## **PLANNING AND ZONING COMMISSION**

### **Monday, September 26, 2016**

**Subject:** Consider making a recommendation on PZ Case No. 16-27; the site plans for 8601 Thomas Avenue.

**DANCE VISION STUDIO  
 SITE IMPROVEMENT PLAN**

SHEET 1 OF 5

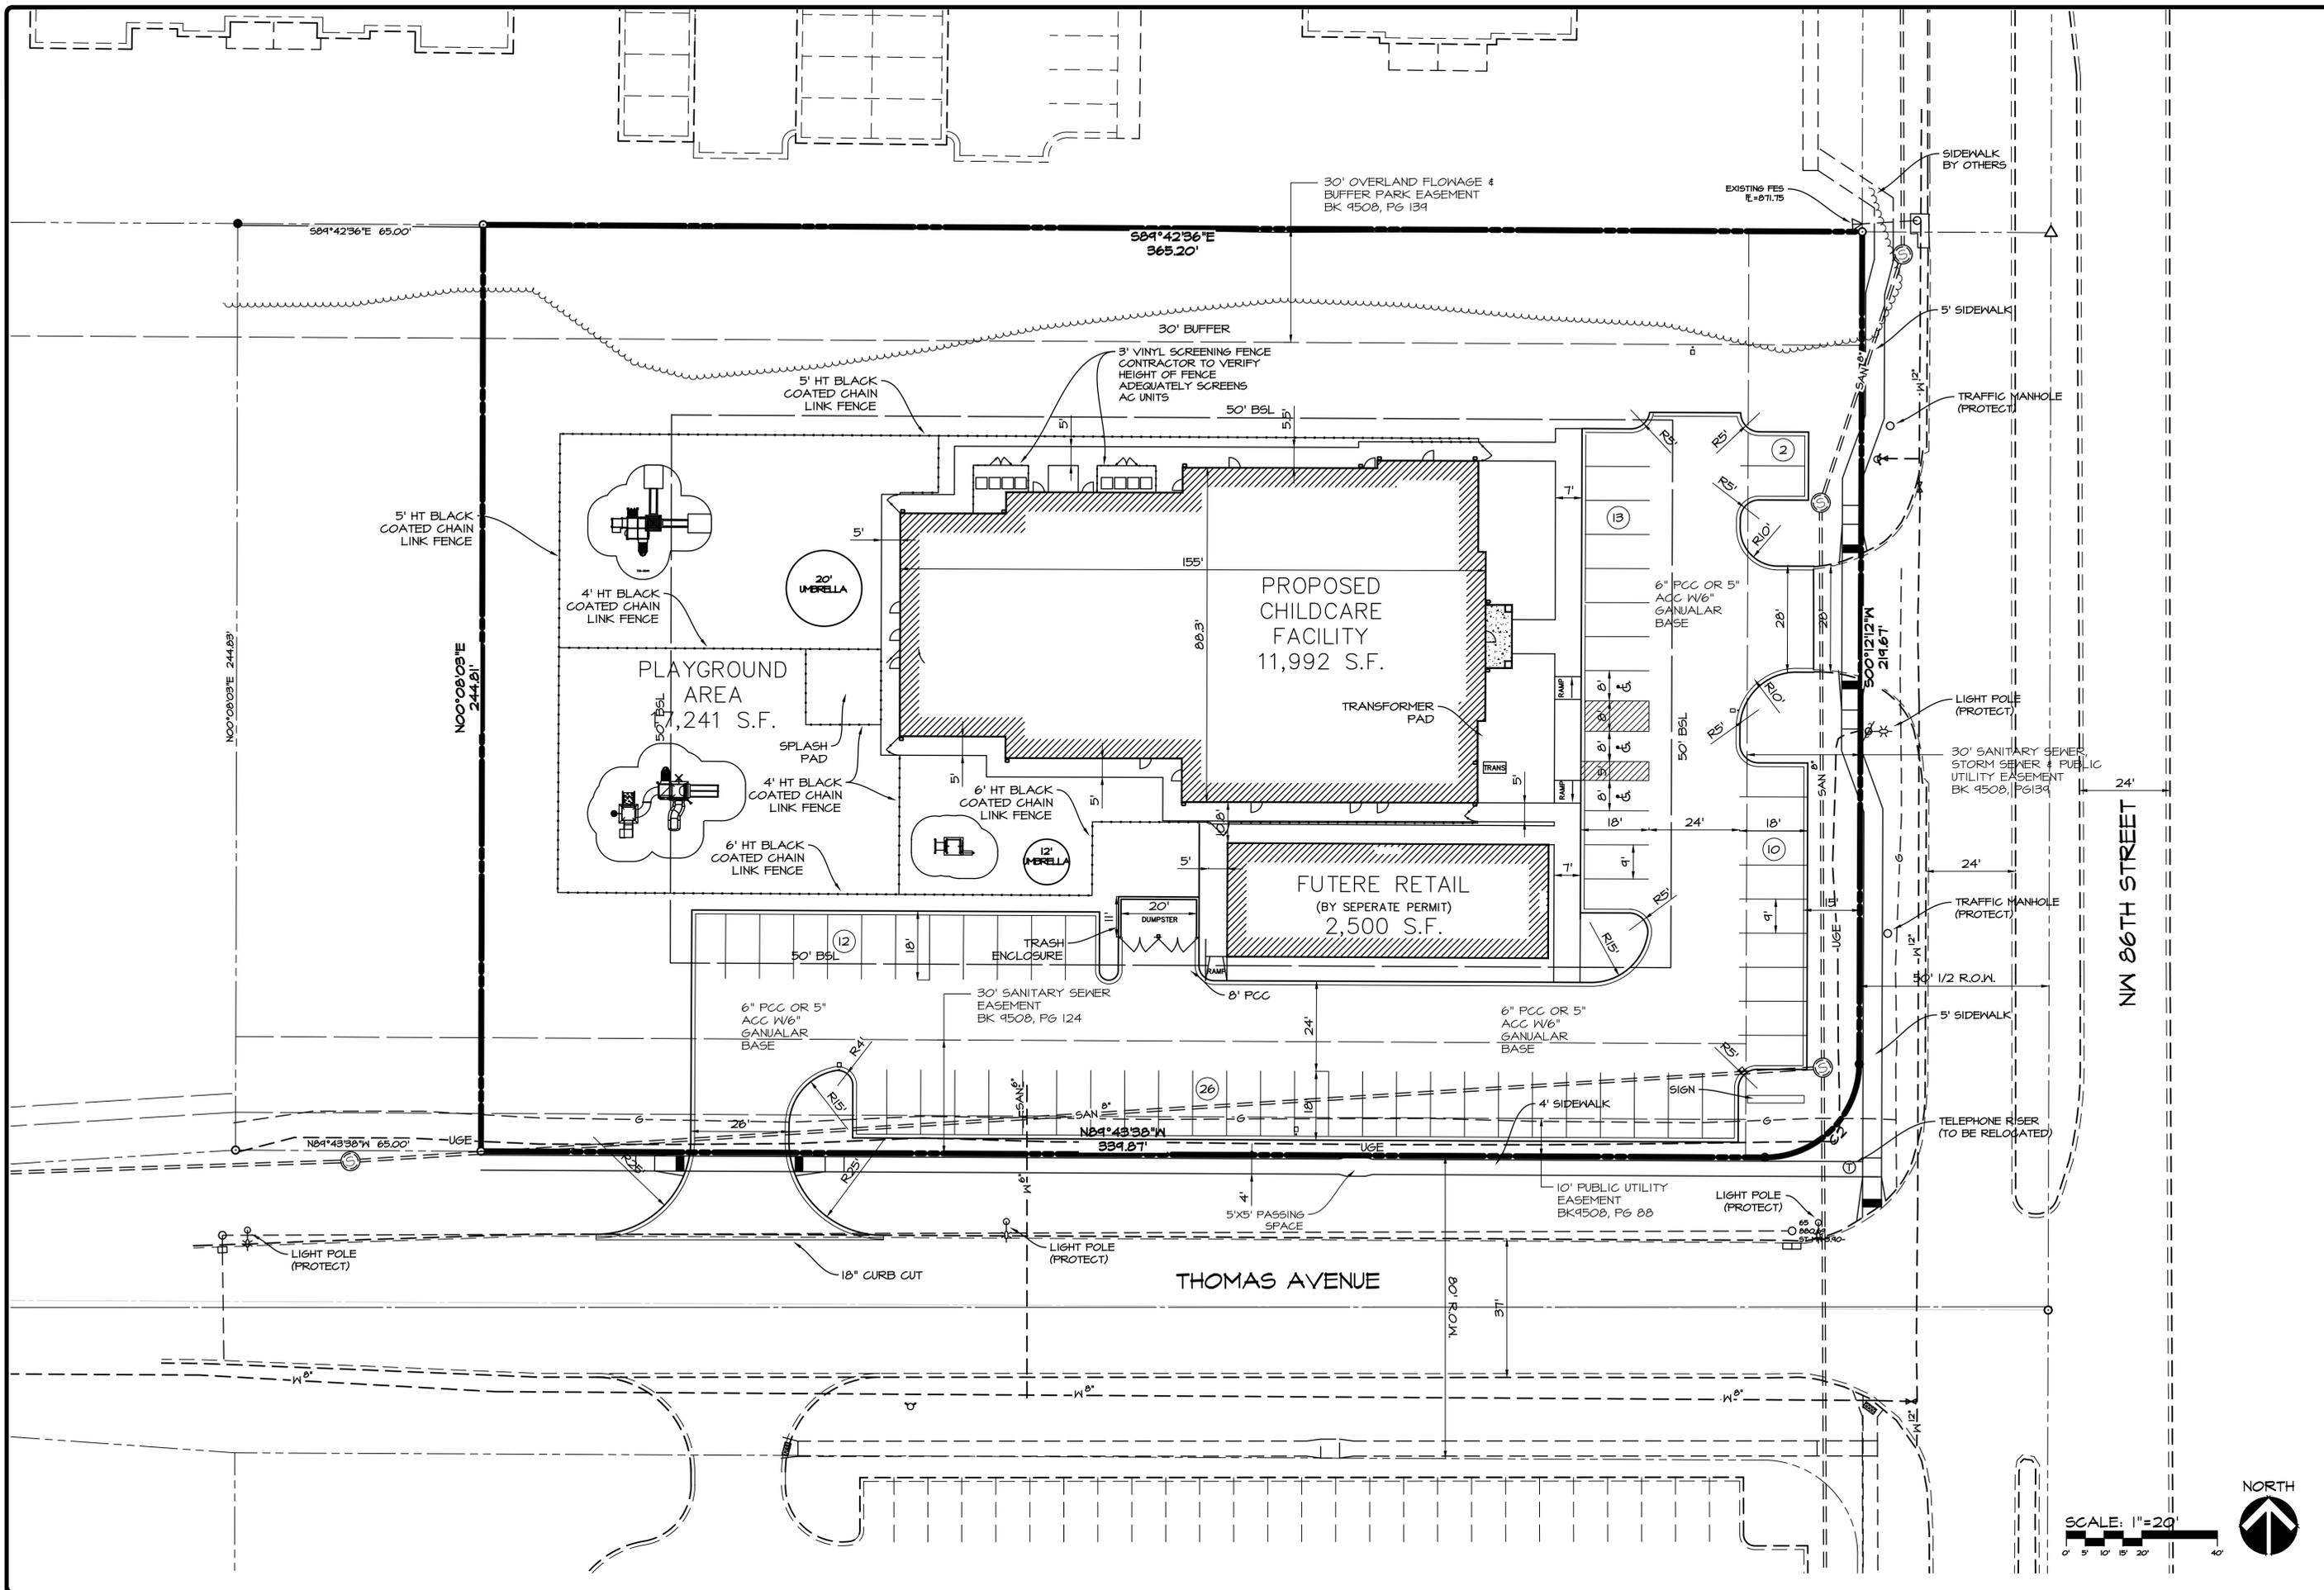
- a. Update the engineer seal and landscape architect seal on the cover sheet to cover all pages of the site plan.
- b. Update the sheet list table on the cover sheet and the sheet numbers on the bottom right of the site plans to identify all sheets of the site plans.

- a. Update the drawing index to identify each of the 4 pages.
- b. Landscape architect seal should state that it covers Sheets 1 – 4 (There is no page 5 or 6).
- c. An engineer seal is required on the site plans and should cover sheets 1 – 4.
- d. Site area shown on the vicinity sketch appears to be the Jethro's location opposite Thomas Avenue from the subject site. Update the vicinity sketch to the correct property.
- e. Note 5 should indicate that all construction will be to 2014 SUDAS and Johnston Supplemental Specifications.
- f. Note 10 regarding a potential traffic study is not required and may be removed from the site plans.
- g. Buffer area may be removed from the calculation to determine open space landscaping requirements. So for this site the area used to calculate open space landscaping would be determined as such:
